Magnolia Public Schools

Ad-Hoc (Facility) Committee Meeting

Approval of MSA-1 Owner Change Orders No. 6 and No. 7

Ad Hoc Committee Agenda Item #:	III.A.—Action Item
Date:	June 3, 2019
To:	Magnolia Educational & Research Foundation dba Magnolia Public Schools (“ MPS ”) Ad Hoc Committee (the “ Committee ”)
From:	Alfredo Rubalcava, CEO & Superintendent
Staff Lead:	Patrick Ontiveros, General Counsel & Director of Facilities
RE:	MSA-1 Change Order Requests 6 and 7

1 BUILDING SECTION
S4.0 SCALE: 1/4"=1'-0"
NOTES:
1. FOR INFORMATION NOT SHOWN SEE ARCH'L PLANS SECTION 1/AS.1
2. ELEVATION TO BE VERIFIED W/ARCH'L PLANS
3. FOR JOISTS/BEAMS/DECK DIRECTION SEE PLANS

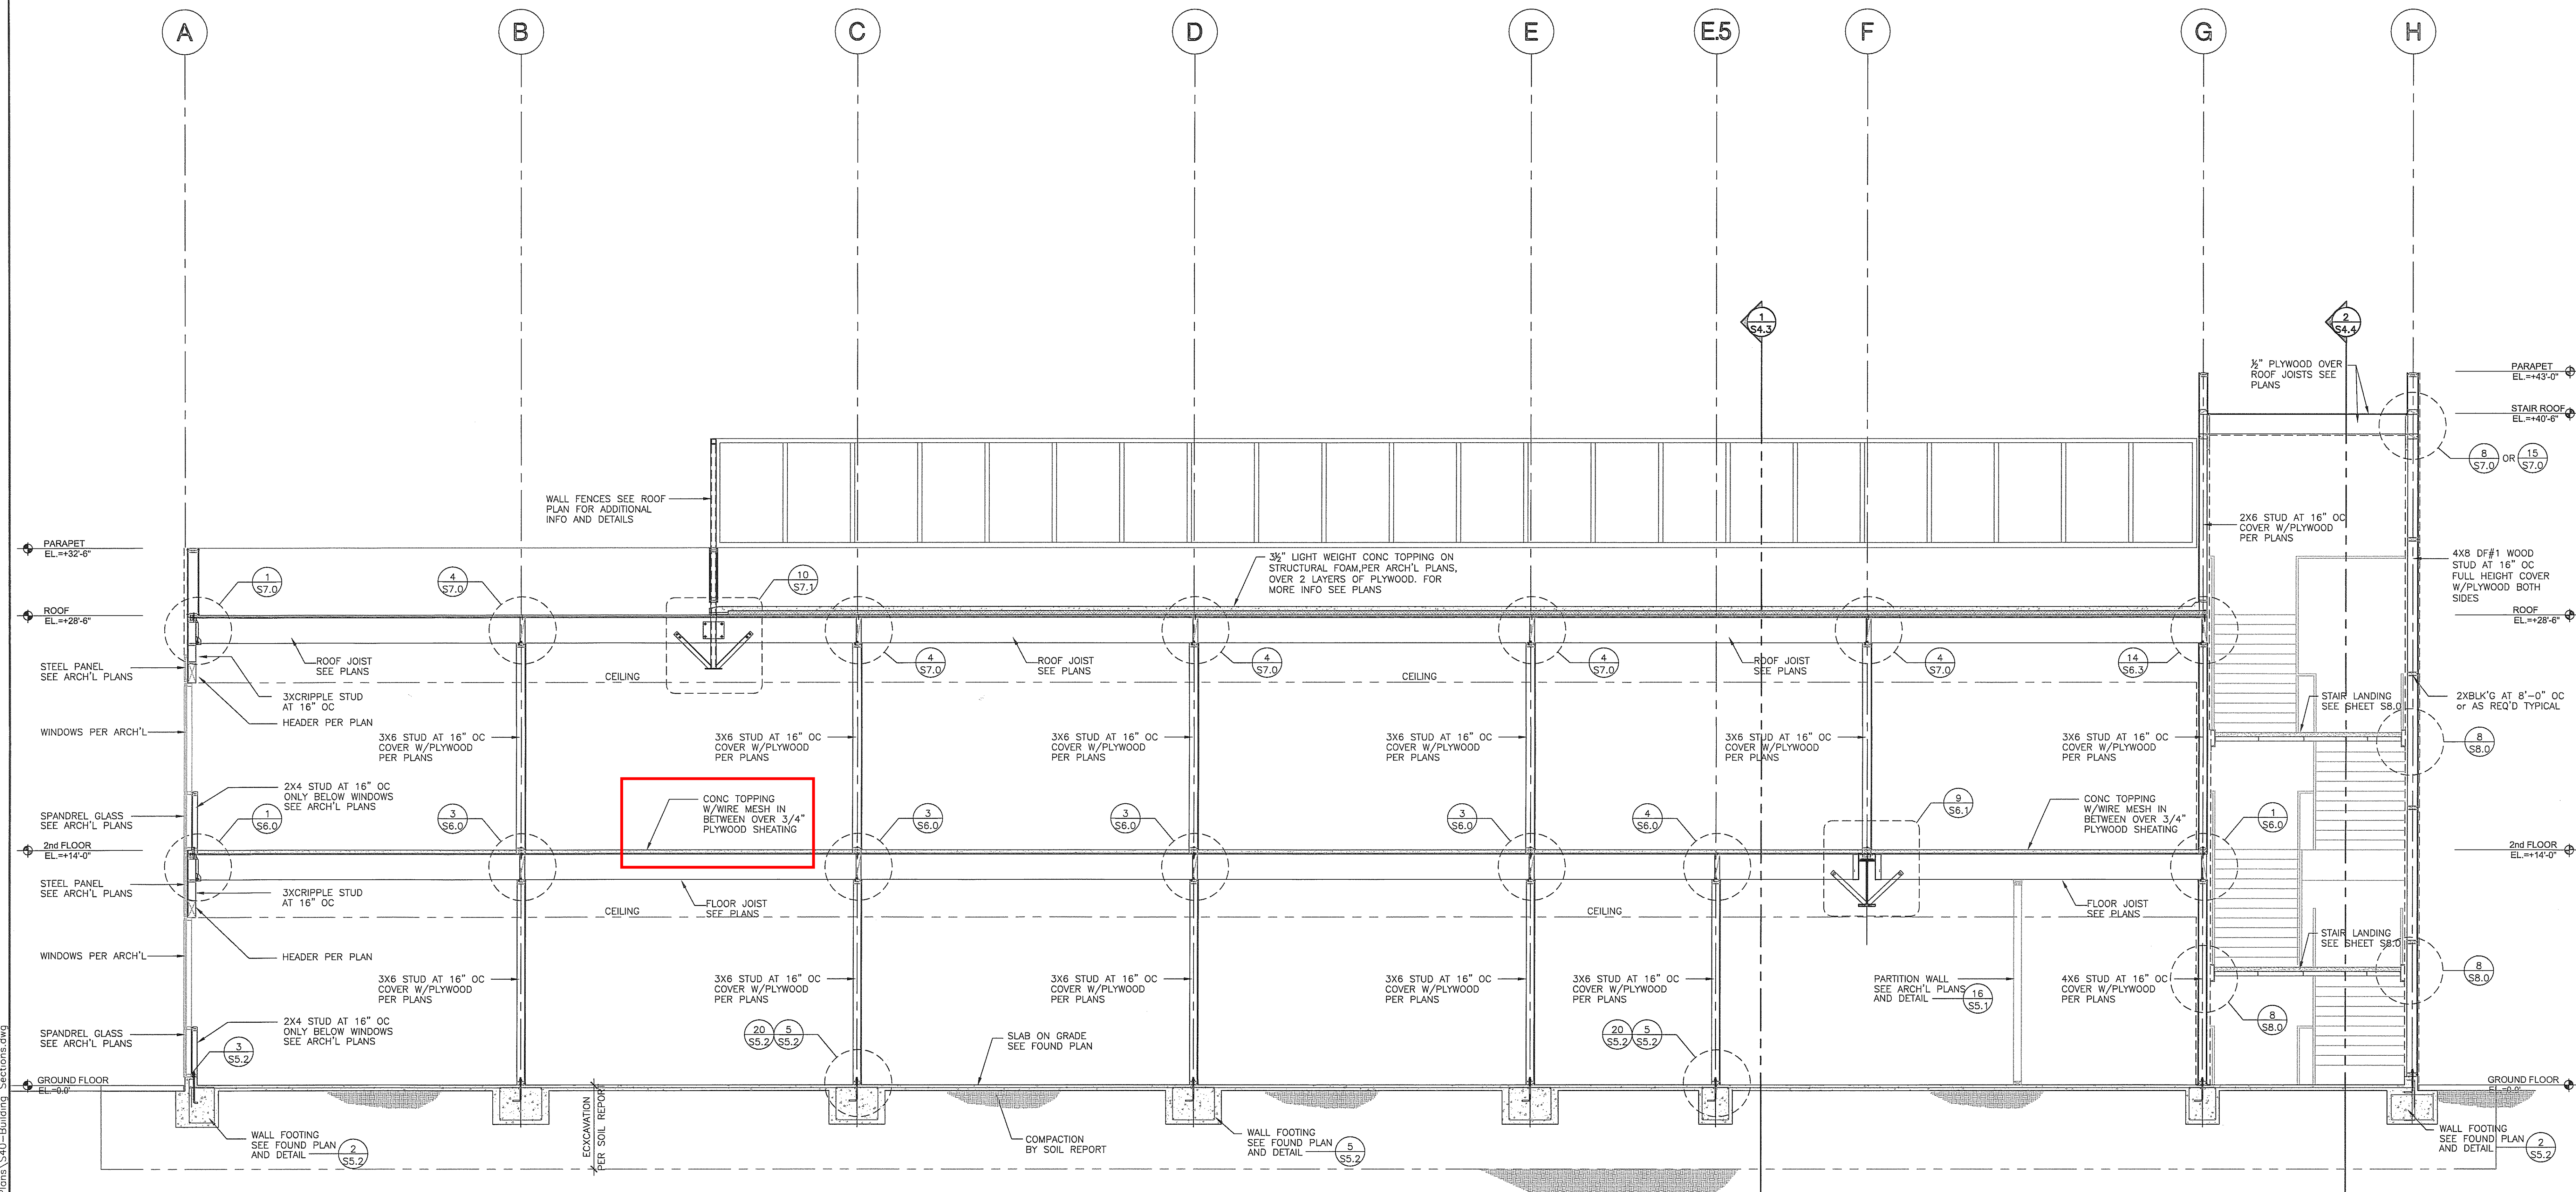
Refer to: S4.0

1. The concrete topping on 2nd floor over plywood is not a standard decking detail and we would like to ensure we are meeting design intent and general functionality.
 - a. Please confirm the +/-2.5" concrete topping slab (4000psi) over ¾" plywood on the 2nd floor is to receive wire mesh per S4.0.
 - b. Please confirm there is NO relief/soft cuts required for this slab.
 - c. Please advise if there are any pre-loading or shoring requirements for the 2nd floor and rooftop decks.

Response to RFI #062 states concrete topping slab to receive wire mesh per note 1 on S2.0. Per OAC meeting on 9/5/2018, owner has requested **fiberglass mesh in lieu of wire mesh**. Please provide a specification for fiberglass mesh.

1. The floor joists and plywood are designed to support the light weight concrete topping.
 - a. Please make sure the concrete is LIGHT WEIGHT CONCRETE. The concrete topping slab receives wire mesh per notes 1 on sheet S2.0.
 - b. No relief/soft cuts is required
 - c. No pre-loading or shoring is required. The plywood and roof/floor framing is designed to support the extra concrete weight. Please make sure all the roof/floor framing and diaphragm are constructed per approved structural set first. Then the concrete topping can be constructed.

PROJECT: MAGNOLIA SCIENCE ACADEMY
 PROJECT ADDRESS: 18220 SHERMAN WAY, RESEDA, CA 91335
 DRAWING TITLE: ENLARGED SITE PLAN
 DRAWN BY: JMM
 DATE: 2/17/2017
 CHECKED BY: JMM
 DATE: AS NOTED
 APPROVED BY: [Signature]
 DRAWING NUMBER: E2.1

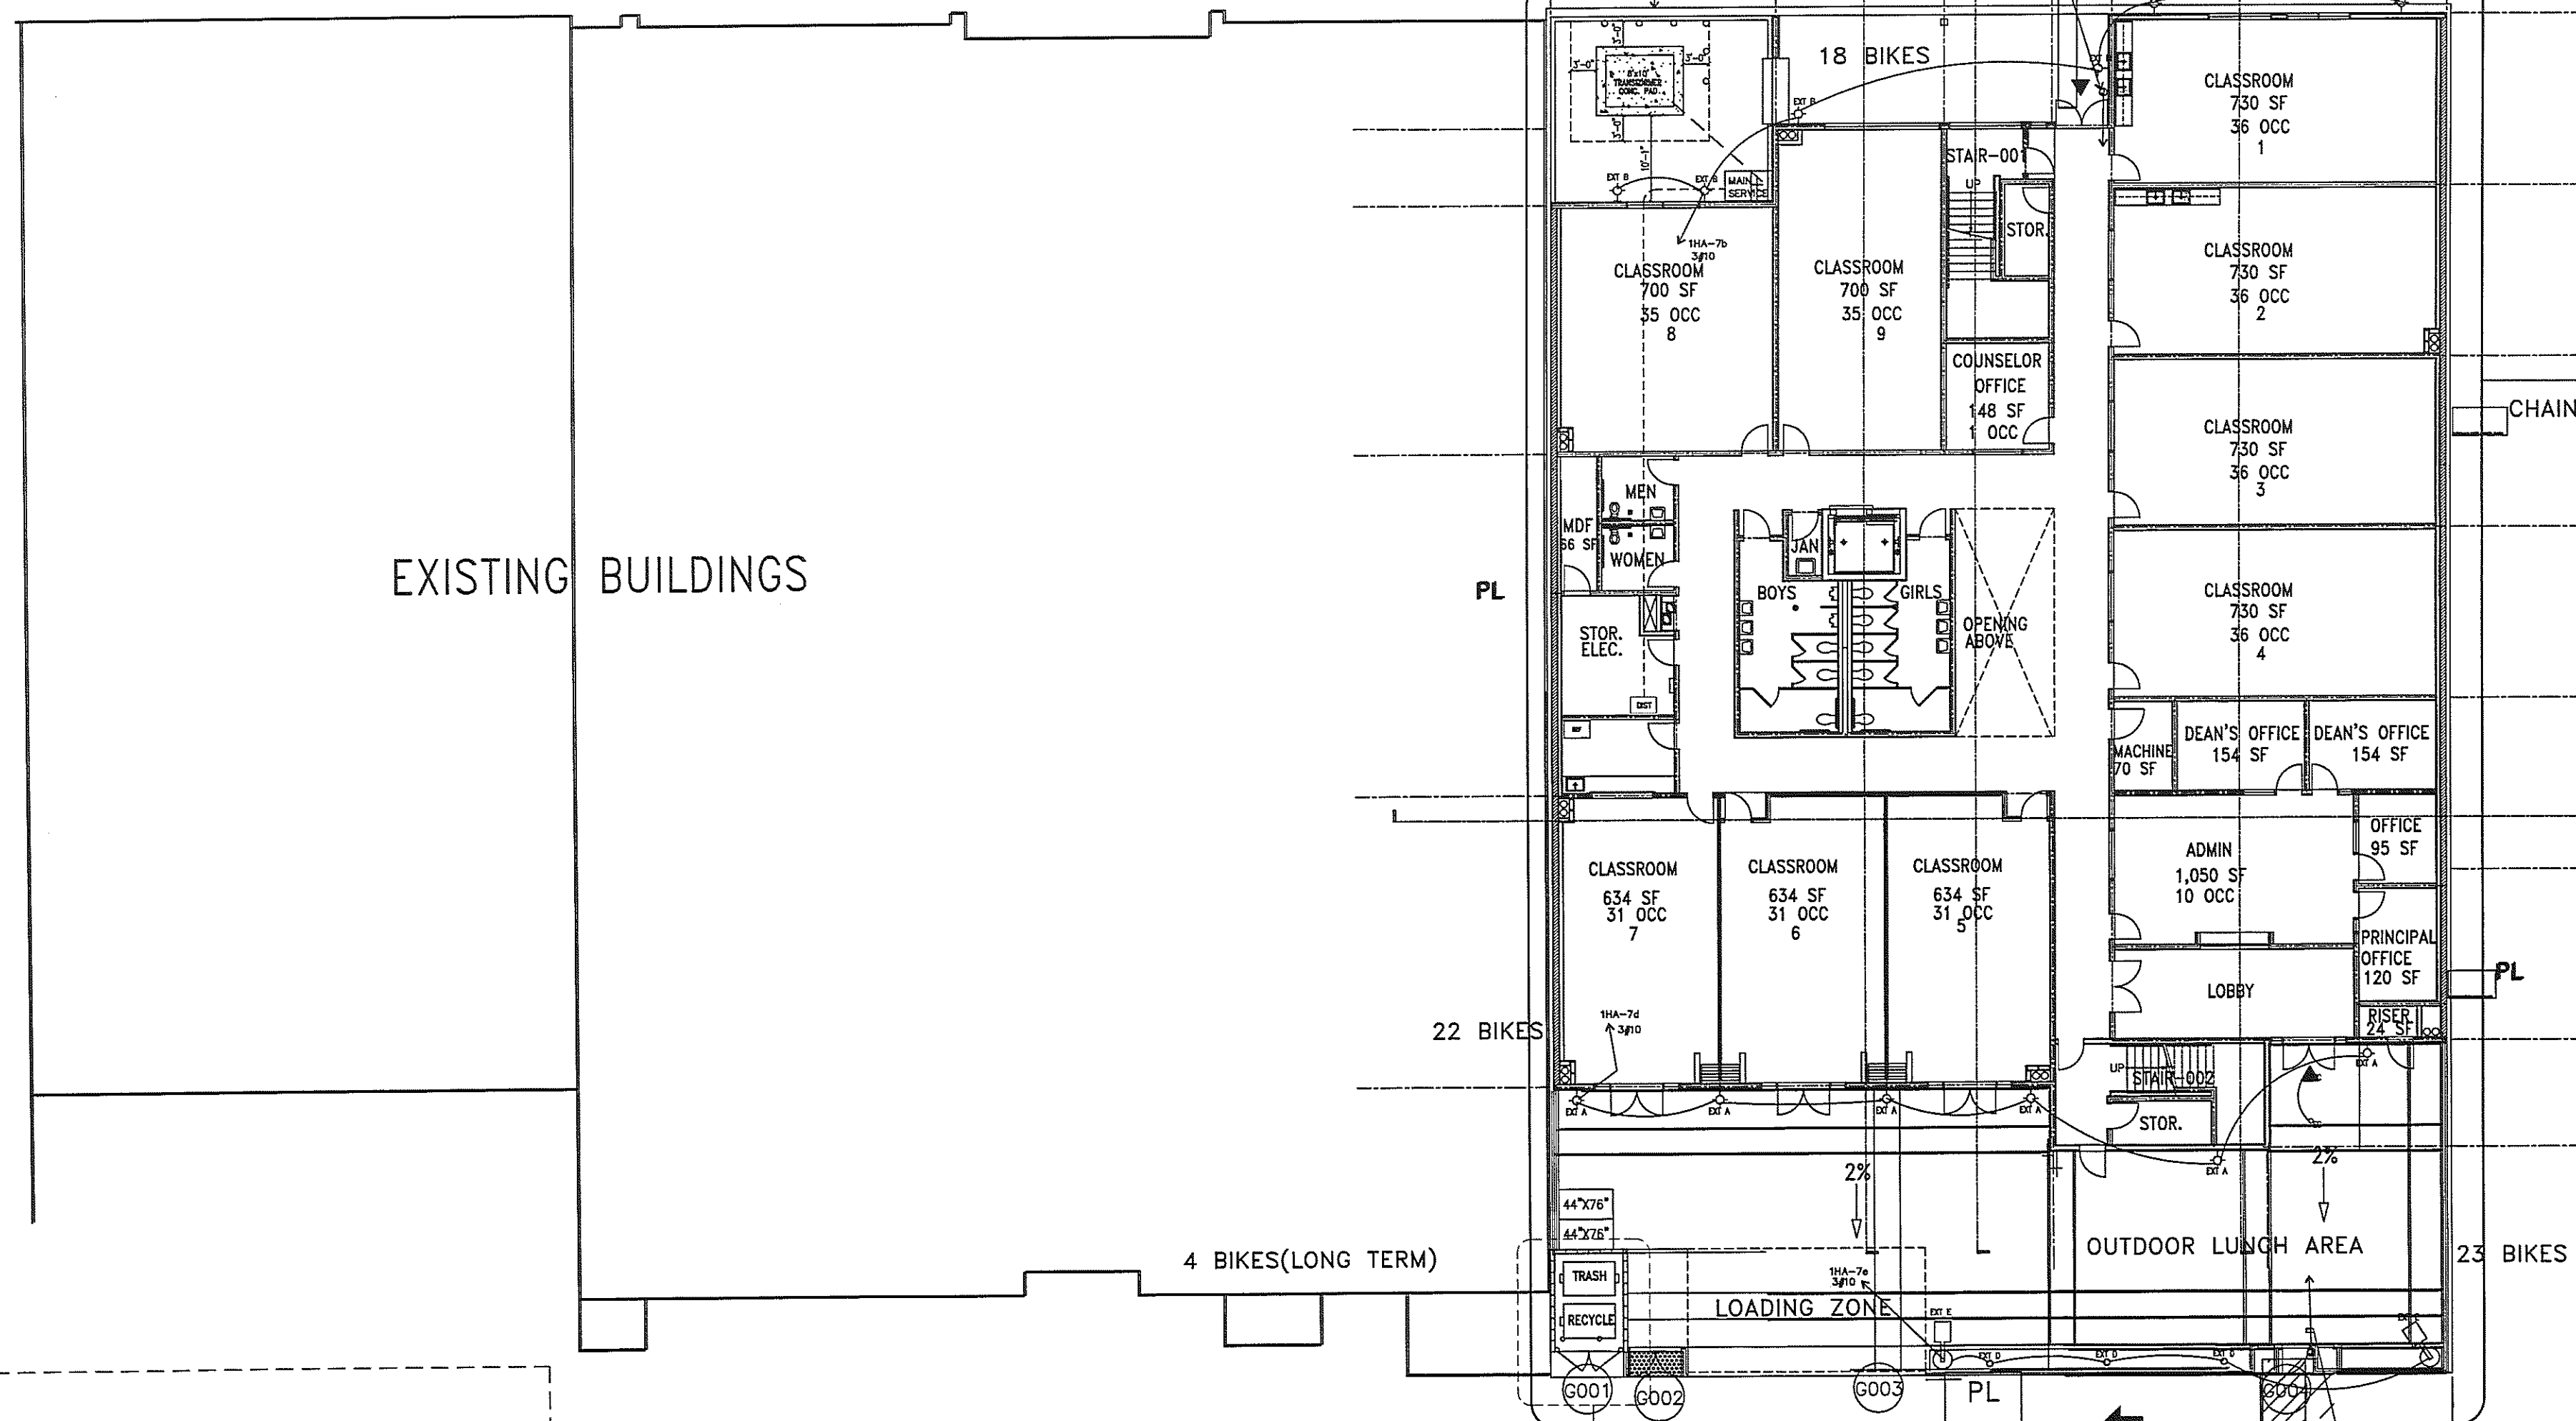
This Potential Change Item (PCI) tracks costs associated with the added labor, materials, and equipment required to install the added LADWP electrical pole not previously included in our scope. Reference E2.1 for site plan.
